**Meeting:** Eastern Area Planning Committee

**Date:** Thursday 2 December 2021

**7a) PL/2021/06348 Rabley House, Poulton, Nr. Marlborough, SN8 2LW**

Retrospective installation of stable windows and external door to tack room to existing barn and external lighting

# Had the original planning application included...

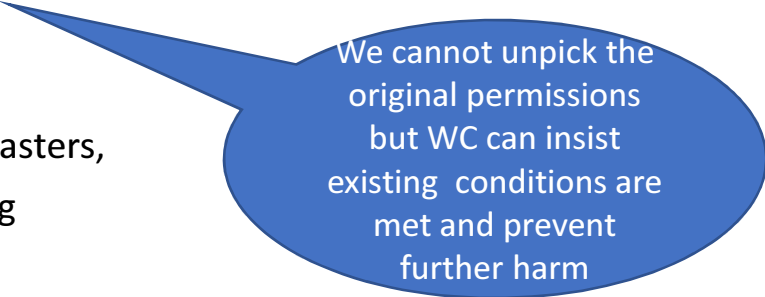
- Barn ridge height on SW side of 7m (1.6m above original)
- 5m high fair faced blockwork only
- 7 uncovered windows on SW boundary side at an external height starting at 2m
- 0.5m gap under the eaves along the SW boundary side (with the windows, allowing permanent egress of internal strip lighting)
- A lorry park sited by the SW boundary fence, 5m from neighbours' front doors and windows
- External lighting
- No soft landscaping
- Removal of existing trees – Elders, Hazels, Oaks, Cotoneasters,
- To stable horses for international standard Event training

**Would it have been approved? No.**

## In more detail 14/02039/FUL

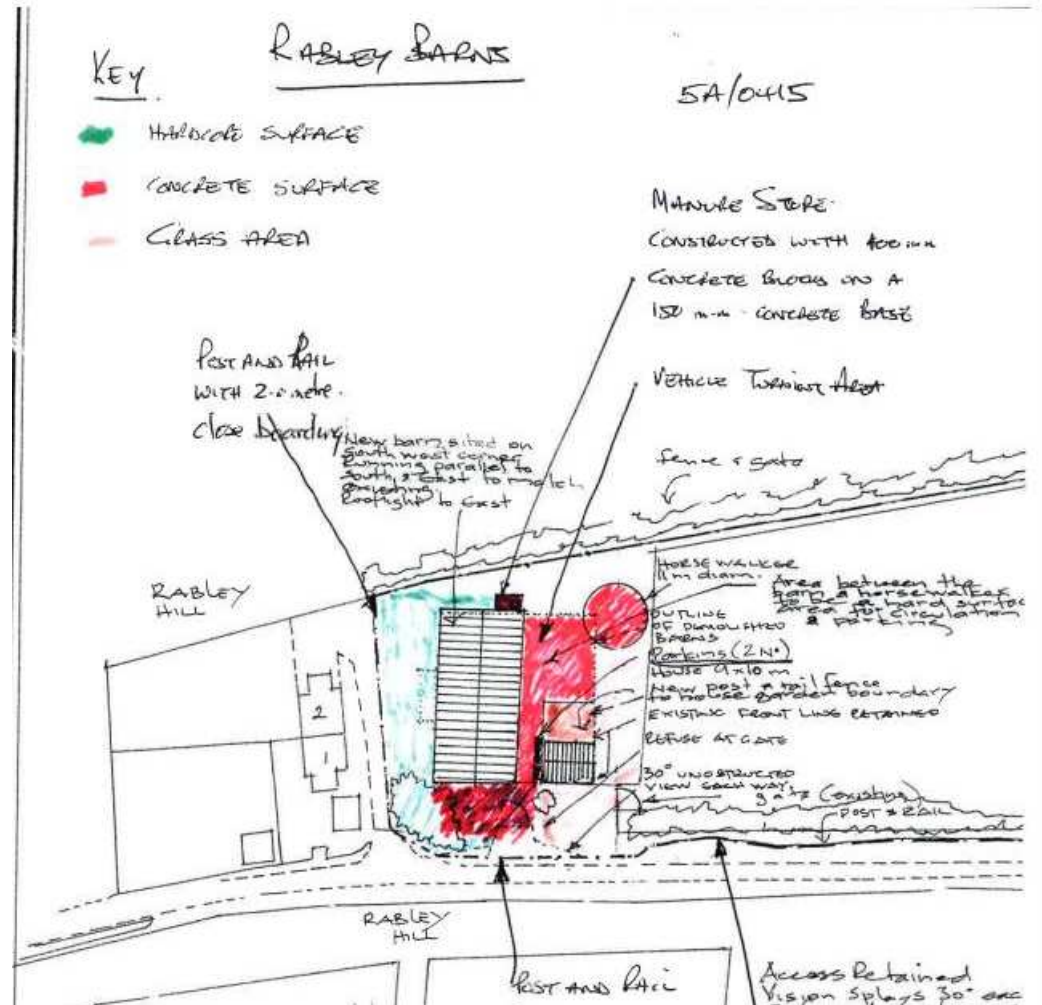
Non compliance

- All soft landscaping comprised in the approved details of landscaping shall be **carried out in the first planting and seeding season following the first occupation of the barn** or the completion of the development whichever is the sooner; ..... Any trees or plants which, within a period of five years, **die, are removed,** or become seriously damaged or diseased **shall be replaced in the next planting season** with others **of a similar size and species,** unless otherwise agreed in writing by the local planning authority.

- No development shall commence until specific details of a consolidated and surfaced vehicle turning space (including dimensions and surface details) has been submitted to and approved in writing by the Local Planning Authority. The plan shall include **details of parking areas for the stud business and the dwelling.** No part of the development shall be first brought into use until **that turning space and parking area** has been completed in accordance with the approved details. Such turning space and parking area shall **thereafter be retained** and kept clear of obstruction at all times.

Ignored

Submitted Plan – considered sufficient to discharge all conditions relating to Landscaping, Turning Areas and Parking, Visibility Splays....

### Submitted Block Plan

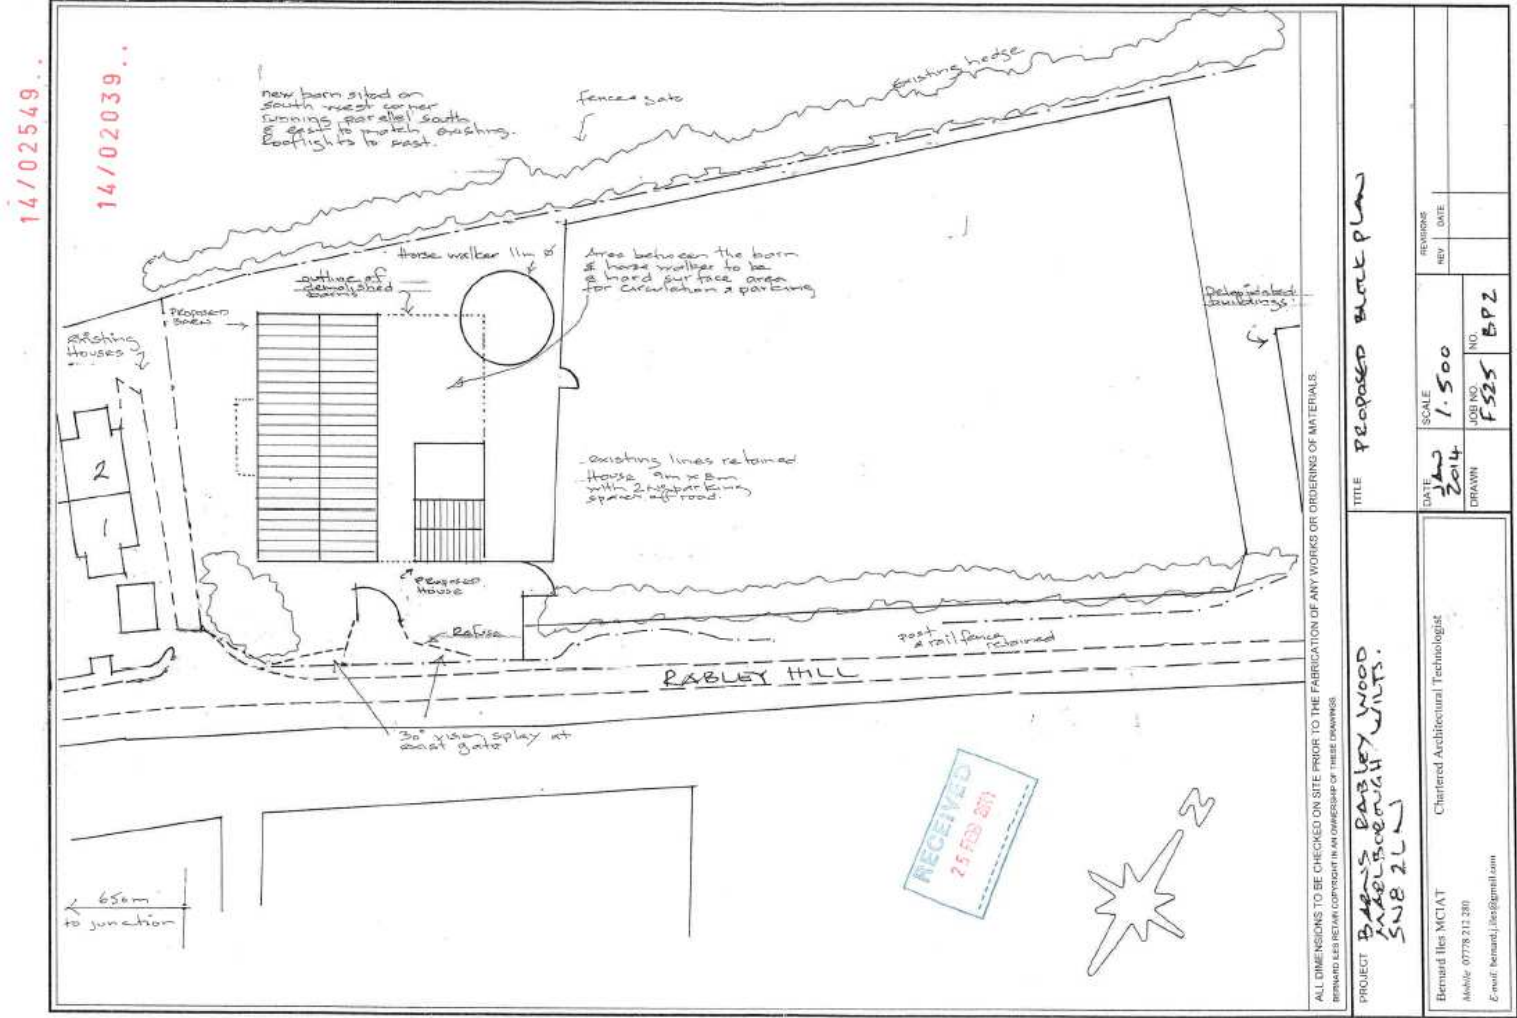
Clearly implying intent to retain trees and location of lorry parking. But trees were removed before the condition discharge.

What conclusion can be drawn?  
Removal of trees to give access to actually intended parking...avoiding harm to their property?

# Huge Light Spill

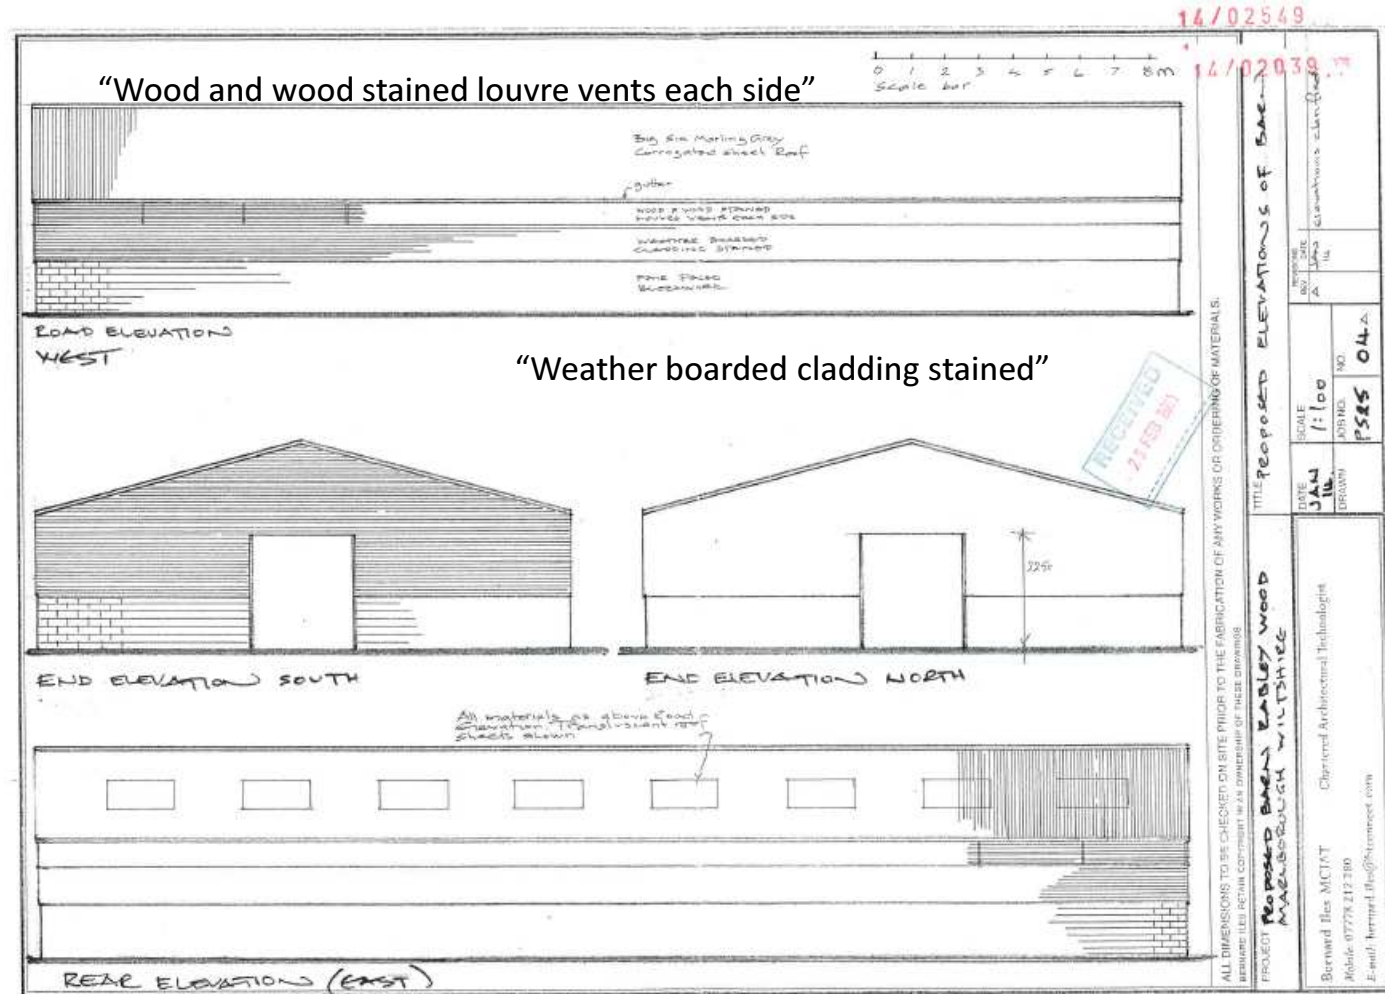
Even with 3m+ high lorries in the way.

*"...although the openings allow more light from the internal lighting to spill out, the level is not considered to be significant enough to warrant the refusal of planning permission"*

How much significant enough?

‘Hit and Miss’ cladding could still be applied and materially mitigate the light spill

**9. Light spill from all internal lights on during summer months at 11.45pm.**

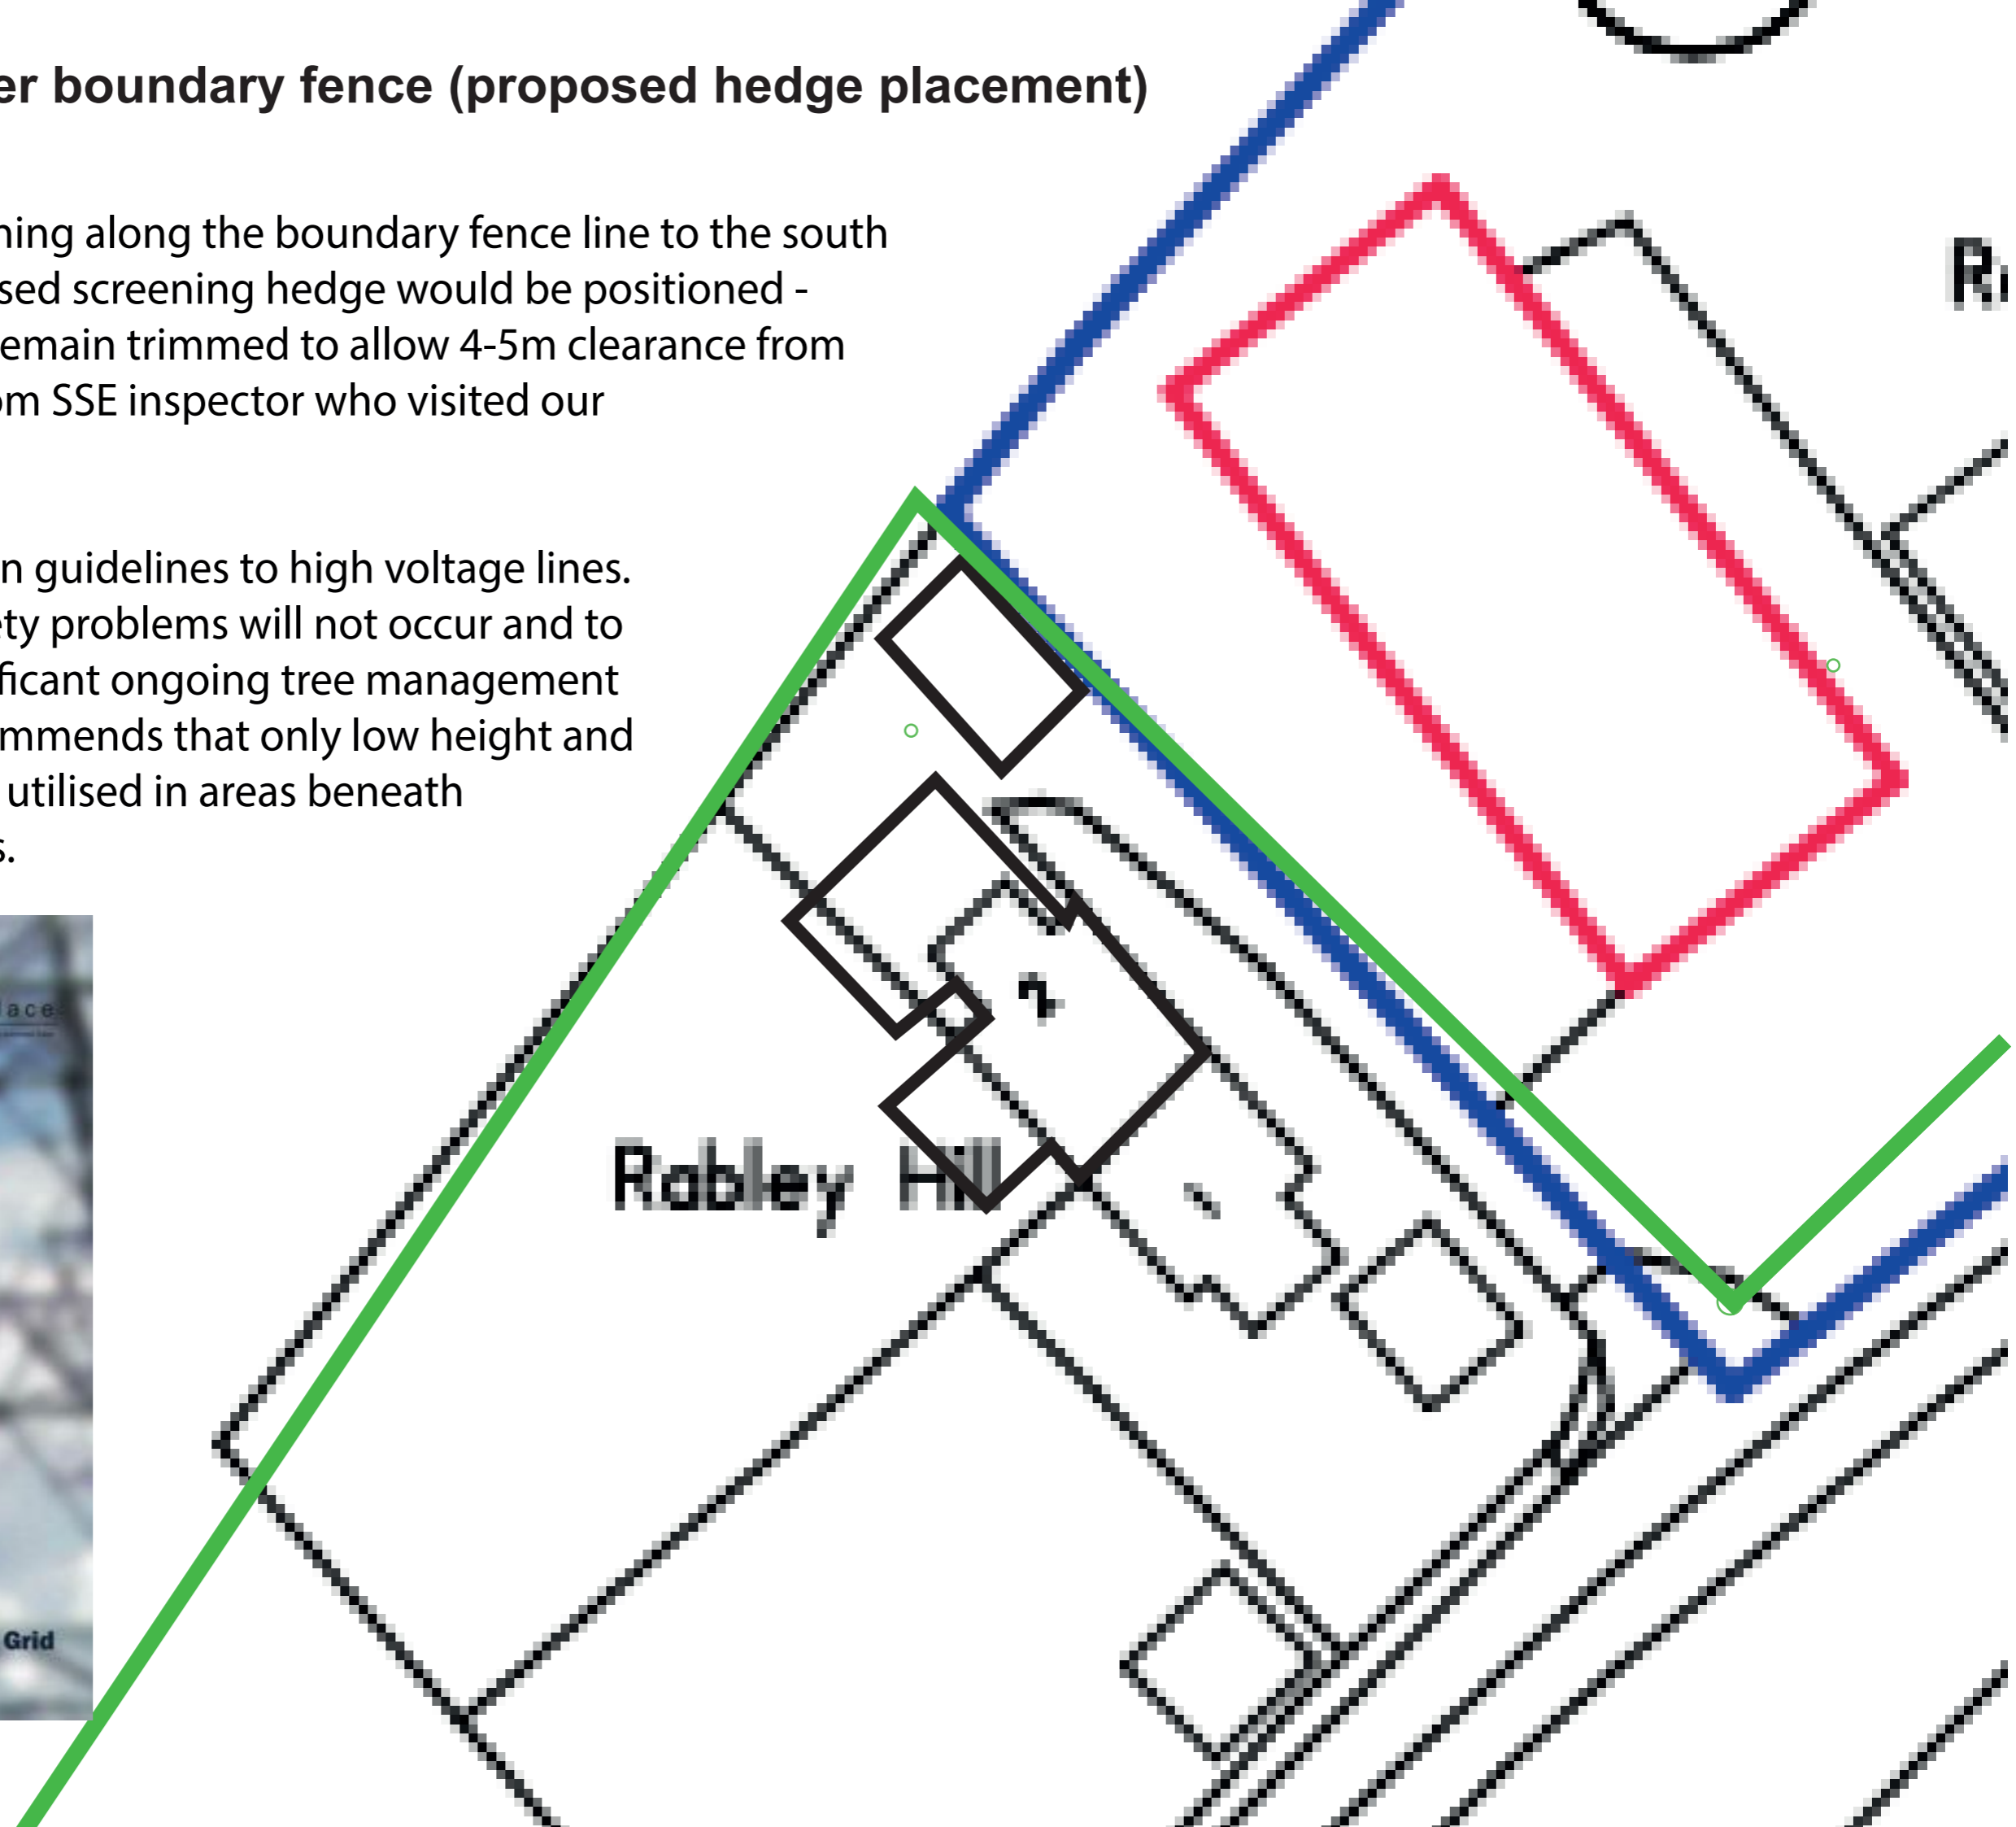
Light spill from internal lighting - only 2 lights at each end of the building were on, but still the light spill through the openings is significant
